Cairn Gorm – the beginner's ski slope planning application (1)

Part 1. The Planning Application.

Site map on .25cm squared graph paper for area calculations – GIS would make this a lot easier!

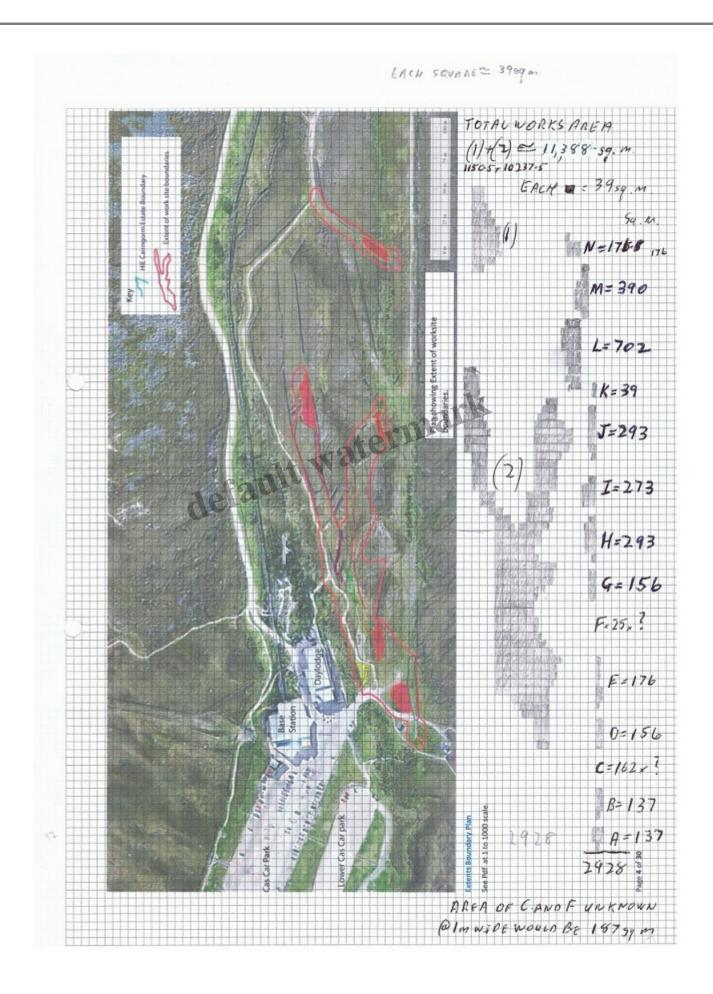
The site area, according to the application, is 0.93 hectares or 9,300 sq. m. There is no indication if this is the work area or the sum of the areas to be bulldozed! I have however worked out that it is the whole site, although by my calculations, which are approximate, the area is actually 11,388sq.m., while the area being bulldozed is over 2928sq.m.

Due to lack of clarity in the application documents, it is not possible to measure areas C & F. However, their total length is 187m. If we assume that a vehicle working on these areas creates a track 3m wide then the area of C + F is 561sq.m., bringing the total to 3489sq.m.
